APPROVED MINUTES OF THE MEETING

September 3, 2009

September 3, 2009 Project: Madison Valley Stormwater Improvements – Phase II

Phase: Schematic Design
Last Reviewed: March 19, 2009; June 4, 2009
Presenters: Celia Kennedy, SPU
Gail Staeger, Nakano Associates
Tom Finnegan, MWH

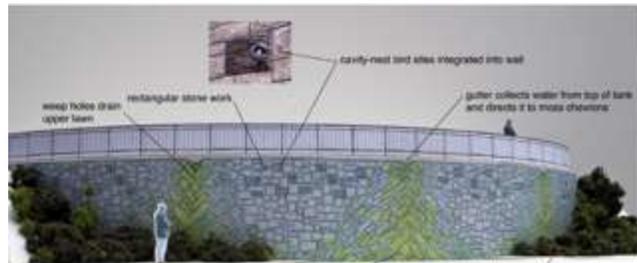
The Commission approves the 60% Design Development Review with a vote of seven to one. The dissenting vote was on the grounds that the various geometries of the design specifically the paving pattern on the lid of the tank, the access hatches and the rhythm of the railing are not integrated and working well together. The Commission has the following recommendations:

- The team is encouraged to review the legibility of how and where water flows to the wall, how it is expressed and how it relates to the wall. Close attention should be paid to the edge where the tank lid and the wall come together.

- The team is also asked to coordinate how the handrail along the edge of the lid and the other vertical and horizontal elements meet.
- The team is asked to resolve the conflicting radial geometry of the access hatches and the linear paving pattern.

The art concept is fantastic, but I think there are some opportunities to tie together the horizontal and vertical planes. The other question I had was in regards to the access hatches and their relationship with the paving pattern.

I am disconcerted by the geometry of the paving pattern and the fact that most people would not get its relationship with the street grid. I am also concerned about the entrance from the truck turnaround at an angle to the geometry of the paving.

I am limited in the potential locations in order for them to function properly. I do not have any flexibility on the size of the hatches.
